## 91 Central Park West, Penthouse A: Restoration/ Relocation/ Rehabilitation(Retained) of the stained glass

LPC amendment

### BRIEF (Amendments to the existing permit):

Restoration of original window and door details on 16th floor of Penthouse A. Restoration is achieved by relocation of view obstructing stained glass to the courtyard facing windows & doors within the same Penthouse A unit. Rehabilitation of the stained glass on the 17th floor of Penthouse A, both the North facing and the East facing windows. Two east facing windows and one courtyard facing window on 16th floor are proposed to be stored.

SHUTTER DOOR OPENING OUTSIDE OPTION

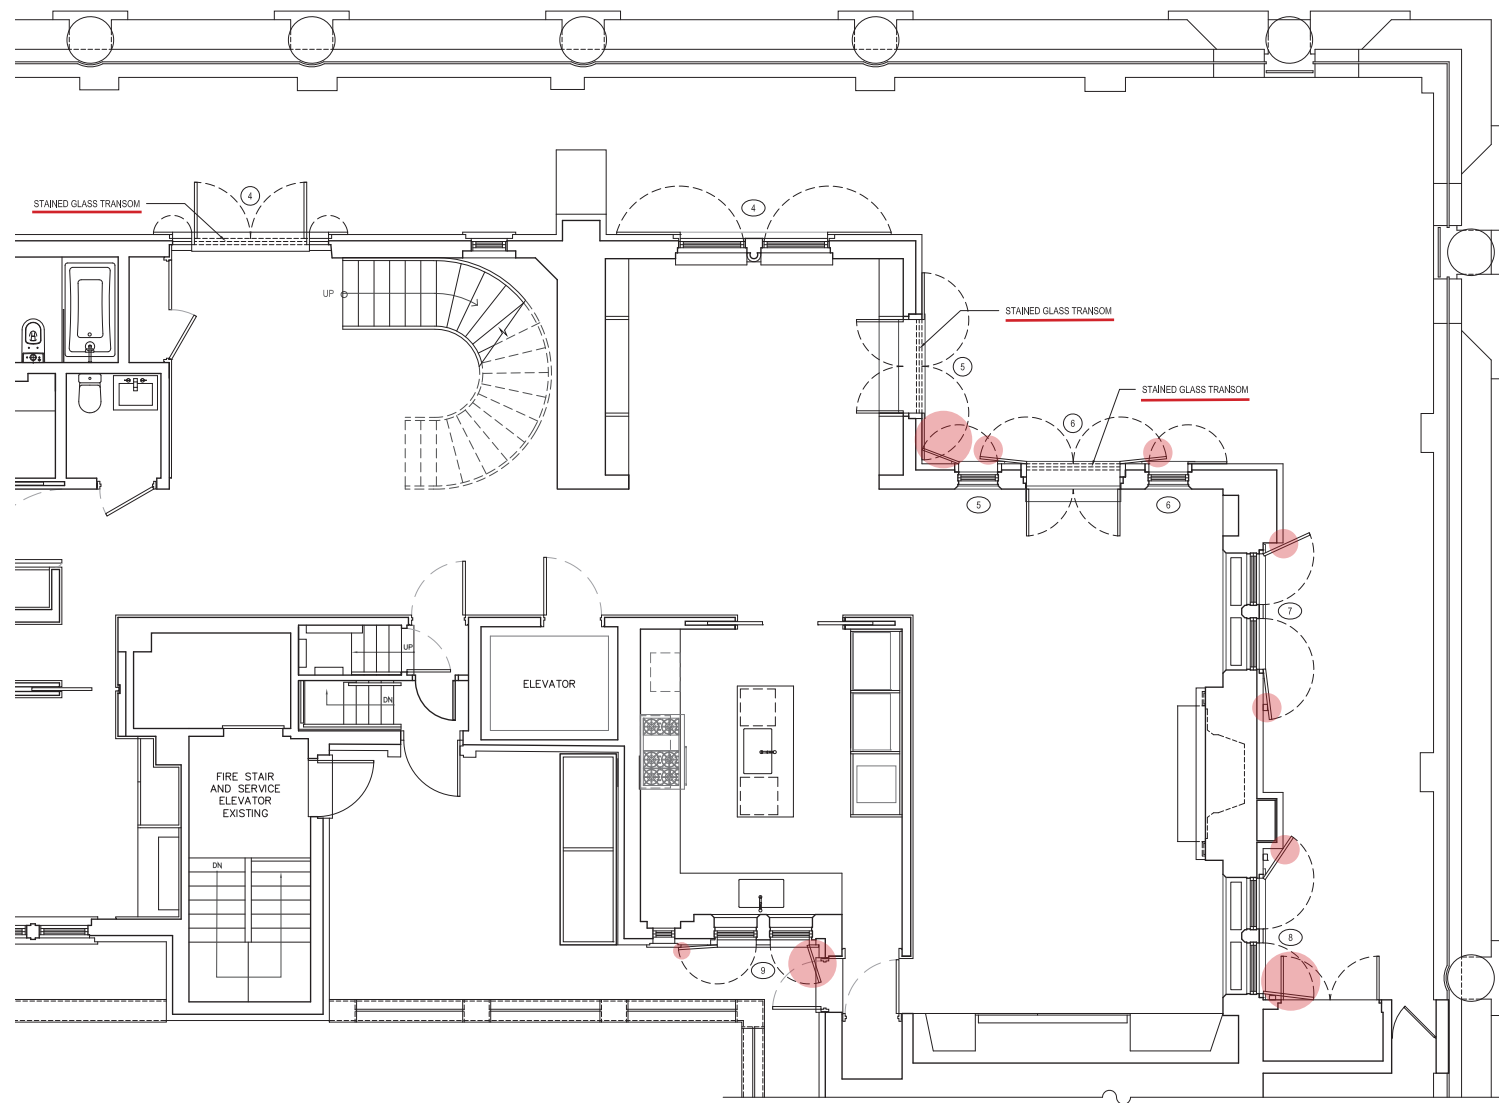
- Originally interior facing stained glasses are prone to damage if placed outside
- 7 doors and windows out of 9 are situated in either in clashing position or/and partially covers the windows positioned next to a door. (This applies to Doors 5 & 6 and Windows 5,6,7,8 & 9).
- Transoms are difficult to be transformed into a shutter system and causes discontinuity of shutter door design solution language.

SHUTTER DOOR OPENING INSIDE OPTION

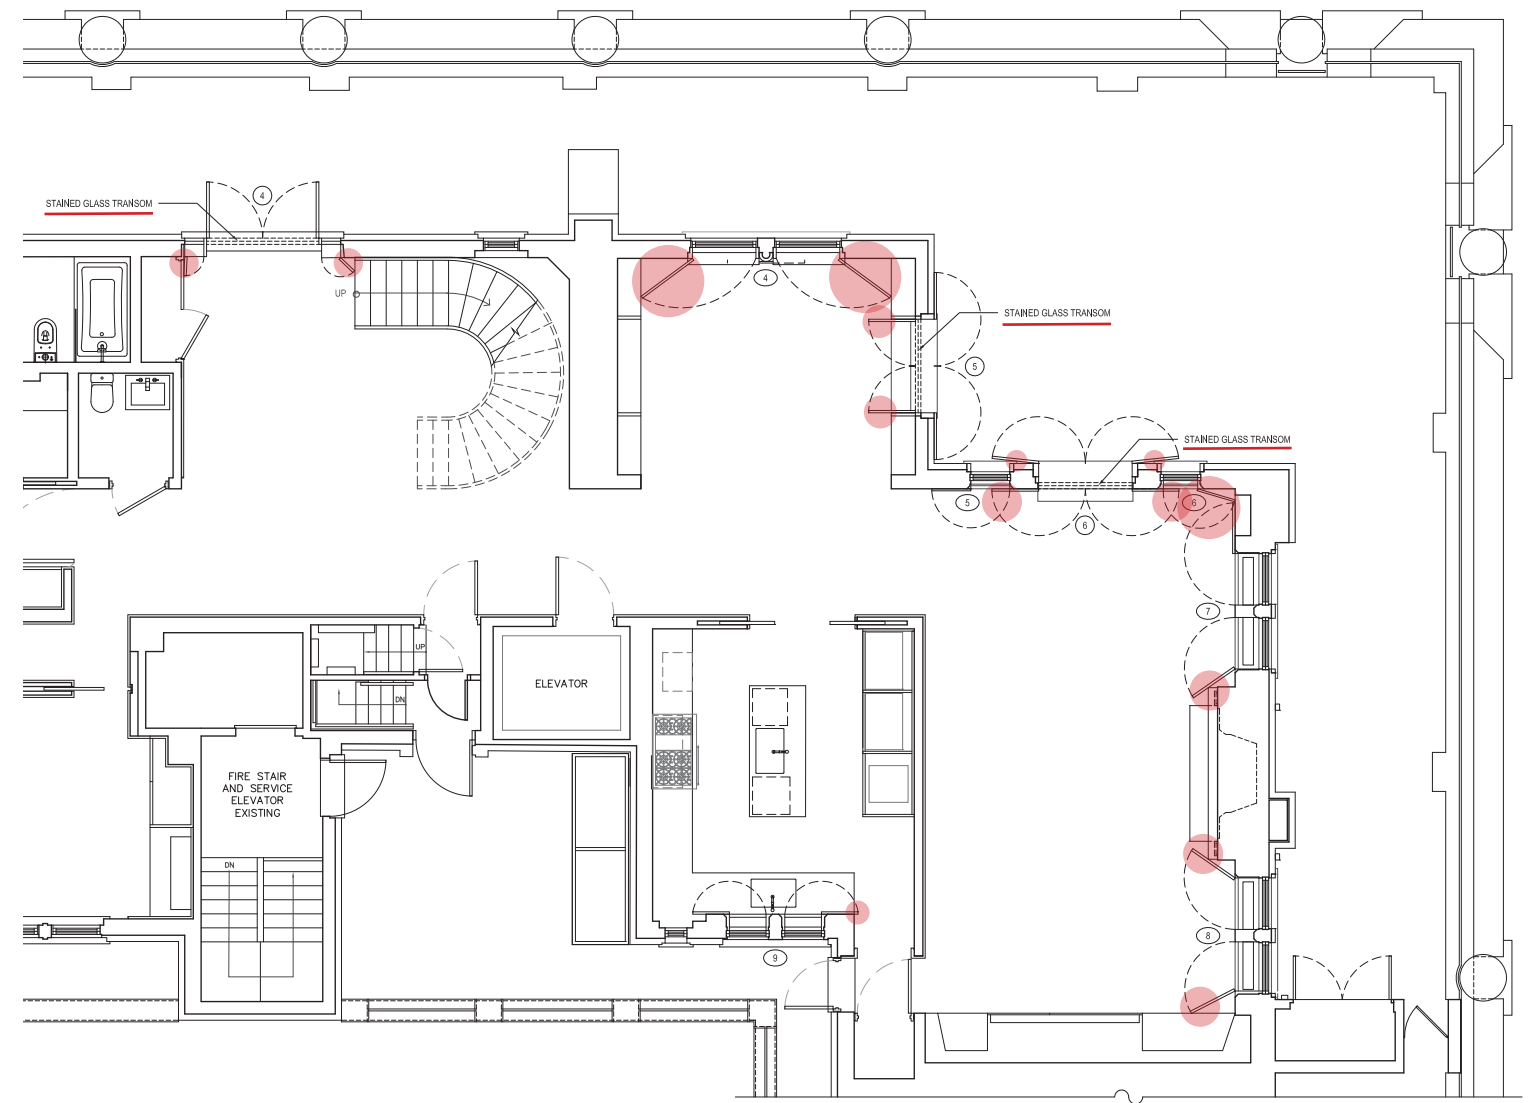
- Every doors and windows are situated in one or more of following: clashing position, partially covers the windows positioned next to a door, extrudes more than the millwork/wall in a fixed position.
- Transoms are difficult to be transformed into a shutter system and causes discontinuity of shutter door design solution language.

RELOCATION  
PROPOSAL

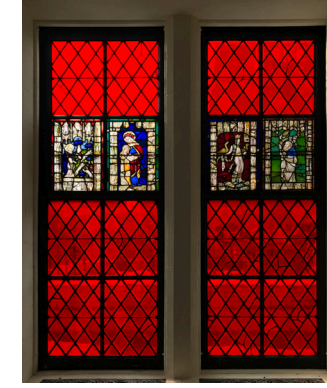
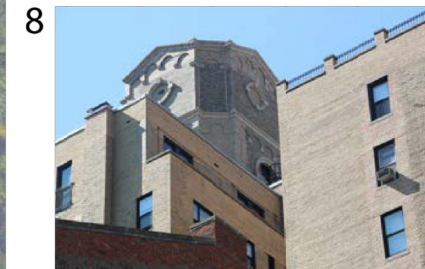
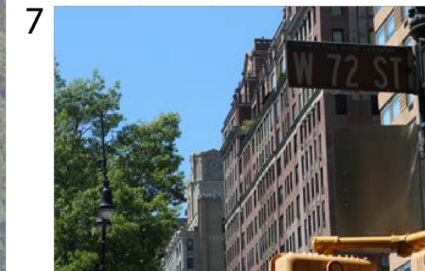
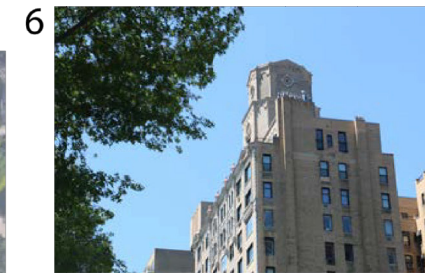
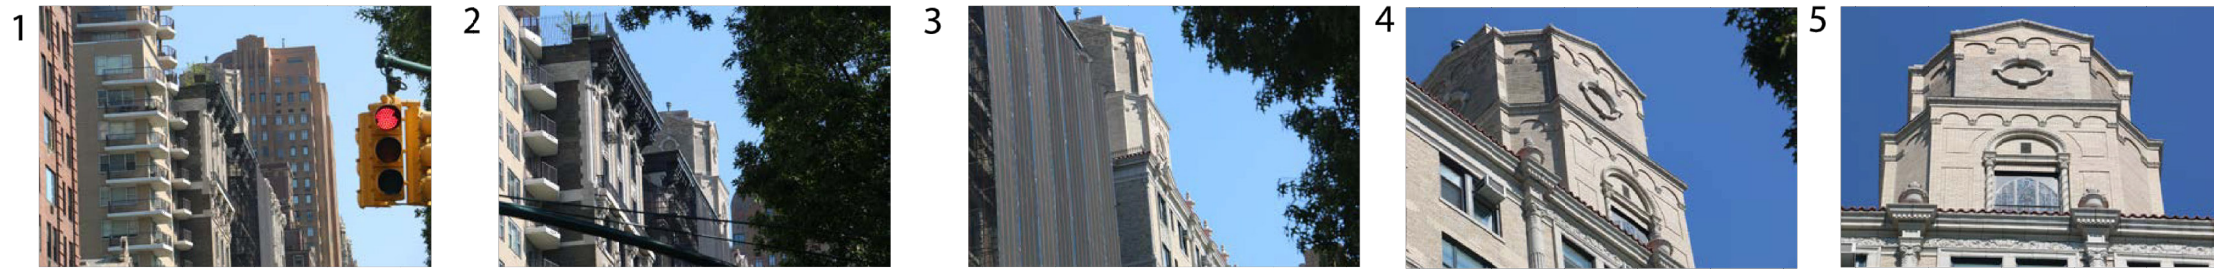
TOTAL STAINED GLASS  
Area of stained glass total = 238 sqft

Area of stained glass retained (medallions only) = 33 sqft  
Area of stained glass removed = 205 sqft

Area of existing stained glass to be relocated = 126 sqft  
Area of proposed relocated area = 107 sqft  
Area of remaining stained glass to be stored = 112 sqft

Area of existing medallion to be relocated = 17 sqft  
Area of proposed medallion relocated area = 17 sqft  
Area of remaining medallion to be stored = 16 sqft

Area of existing colored glass to be relocated = 109 sqft  
Area of proposed colored glass relocated area = 91 sqft  
Area of remaining colored glass to be stored = 96 sqft
